UNITED STATES PATENT AND TRADEMARK OFFICE

APPLICATION NO.	FILING DATE	FIRST NAMED INVENTOR	ATTORNEY DOCKET NO.	CONFIRMATION NO.
10/762,992	01/22/2004	Mark Zieff	30394-101	5992

Office Action Summary

DETAILED ACTION

Fig. 5

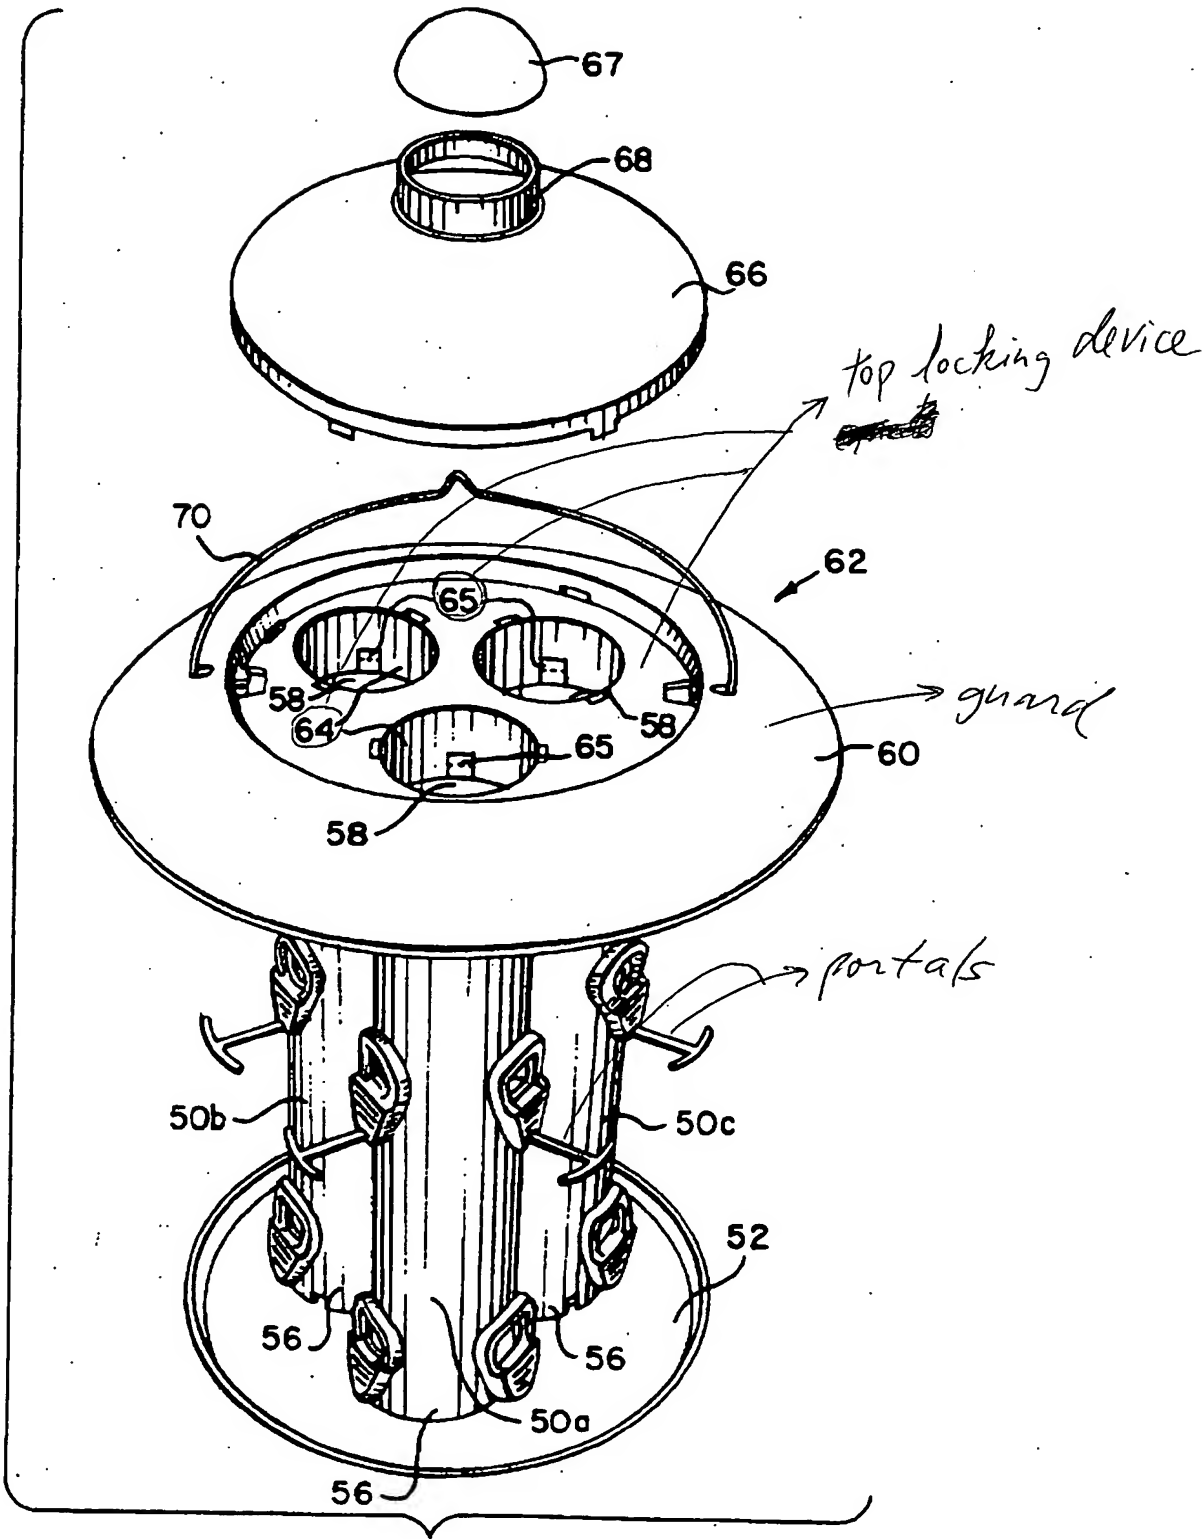
For claim 1, Walter et al. disclose a squirrel proof bird feeder, comprising: (a) a base (52); (b) one or more feeding chambers (50a, 50b, 50c), wherein one end of said chambers are securely affixed to said base; (c) a top locking device (see Figure 5 attached at the end of this Office Action), wherein an end of said chambers opposite to said base are securely disposed within said top locking device; and (d) a guard (see Figure 5 attached at the end of this Office Action) that is disposed along a surface of said top locking device, wherein said guard has one or more guard units, wherein units in apposition are securely adjoined to one another, and wherein said guard extends beyond a feeding chamber so as to prevent said squirrel from accessing said feeding chamber.

For claim 4, Walter et al. disclose said one or more feeding chambers further comprise one or more portals (see Figure 5 attached at the end of this Office Action).
